REFERENCE	BT_2011_FR20_14_UK
DATE	June 28th, 2011
SUBJECT	new camshaft actuator, fuel pressure sensor mounting
PART	camshaft actuator, fuel pressure sensor mounting kit

View on top of the cylinder head

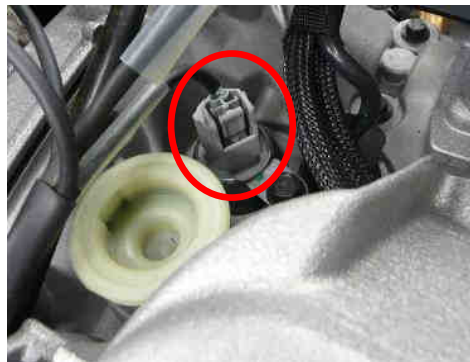
The Camshaft actuator has been modified and now includes fly wires. This modification isolates the connector from vibrations. No modification needed on the engine loom connector.

New one with fly wires

It is now available under the reference 77 11 166 735.

Both old and new types are now allowed.

Note: Renault Sport advises to change the part with a new one when removed from the cylinder head.
